RE: **Recall Campaign Launch Notification**

**Replace Rear Door Latches**

**MY19-21 463 (G-Class)**

SUBJECT: **Model G-Class vehicles (463 platform)**  
**Model year 2021**  
**Replace Rear Door Lock – Code X20 (MY21)**

**Figure 2**

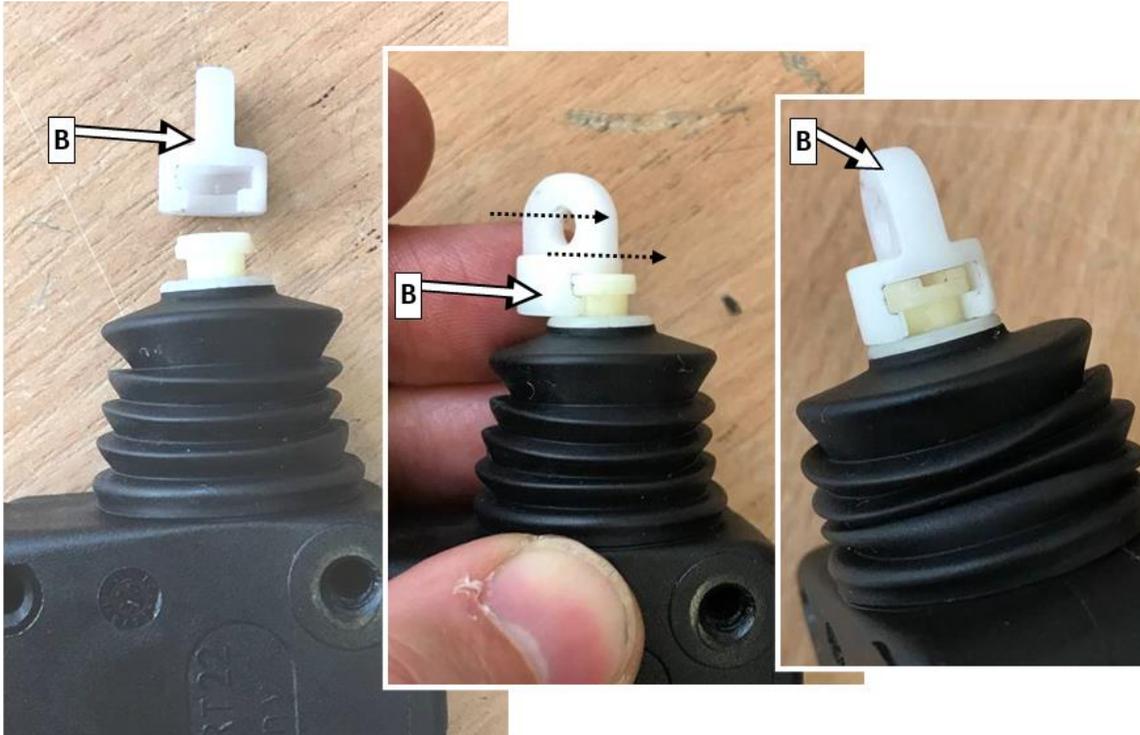
4. Replace mounting clips (**B, Figure 2**) on removed actuator motors for central locking system.

**i** Mounting clips are included in the parts kit and **must be replaced**.

Figure 3

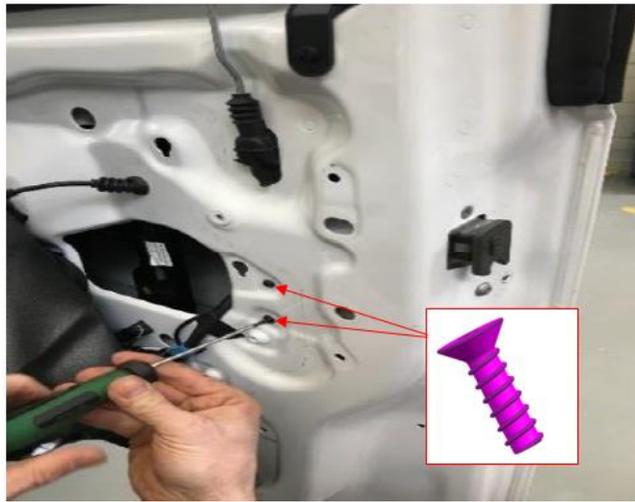
5. Complete unit consisting of door lock, actuator motor of central locking system with release cable, and door locking knob prior to installation and insert into door to assemble.
6. **Mounting screws (Figure 3)** for actuator motor for central locking system **must be replaced** and are included with the parts kit.
